APPLICATION NO.	FILING DATE	FIRST NAMED INVENTOR	ATTORNEY DOCKET NO.	CONFIRMATION NO.
10/595,366	04/12/2006	Byung-moo An	1114.004	8238
21176 7590 06/06/2007 SUMMA, ALLAN & ADDITON, P.A. 11610 NORTH COMMUNITY HOUSE ROAD SUITE 200 CHARLOTTE, NC 28277			EXAMINER RIPLEY, JAY R	
			ART UNIT 3679	PAPER NUMBER
			MAIL DATE 06/06/2007	DELIVERY MODE PAPER

Office Action Summary

10/595,366

AN, BYUNG-MOO

(Bridges Figure 1)

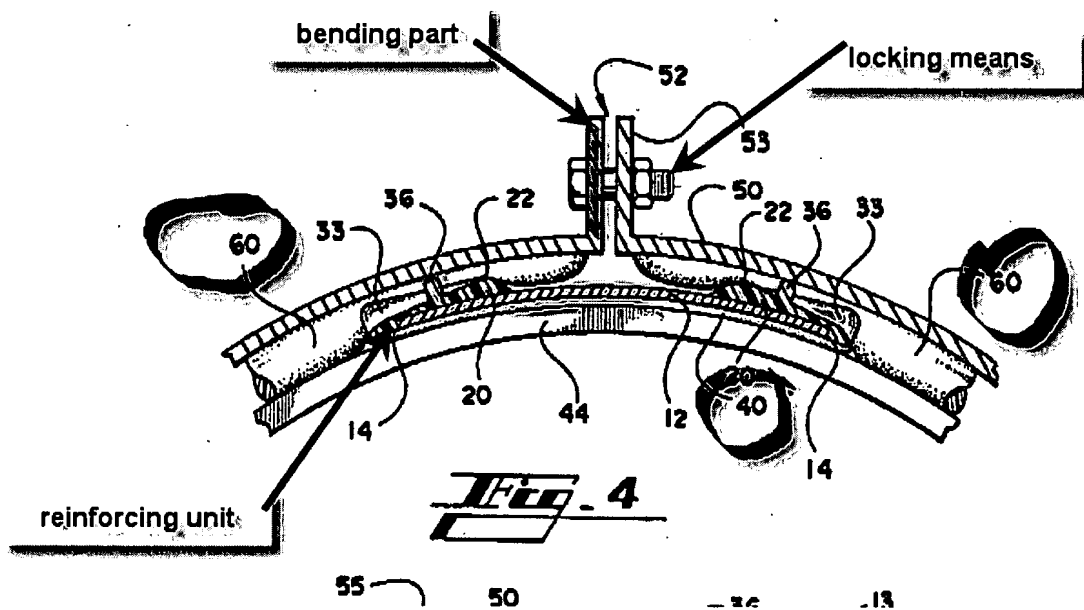
7. In regard to claim 1, Bridges discloses in Figures 1, 4, 6, below, a pipe joint, comprising:
a body part provided by rolling a planar material to form a cylindrical structure;

9. In regard to claim 2, Bridges further discloses in Figure 1, above, that the reinforcing unit further comprises a stop means having a stepped shape.
10. In regard to claim 3, Bridges further discloses in Figure 3, below, that the body part is stepped around a predetermined portion thereof so that upper and lower parts of the body part differ in inner and outer diameters from each other.

(Bridges Figure 4)

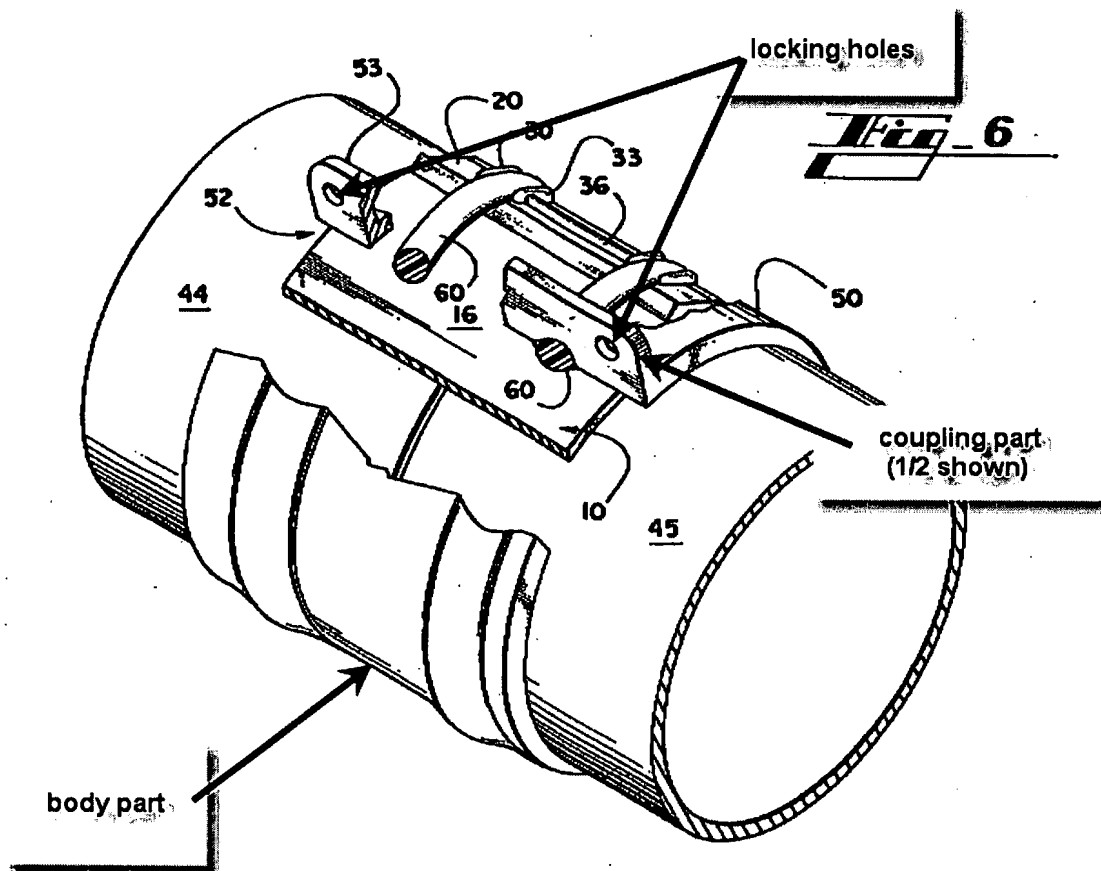
11. In regard to claims 4/1, 4/2, and 4/3, Bridges further discloses in Figure 4, above, a sealing unit provided inside each of the body part (arcuate gasket part 60) and the reinforcing unit (circumferential sealing pad part 40).

13. In regard to claims 6/1, 6/2, and 6/3, Bridges further discloses in Figure 4, above, that each of the coupling parts comprises a bending part.
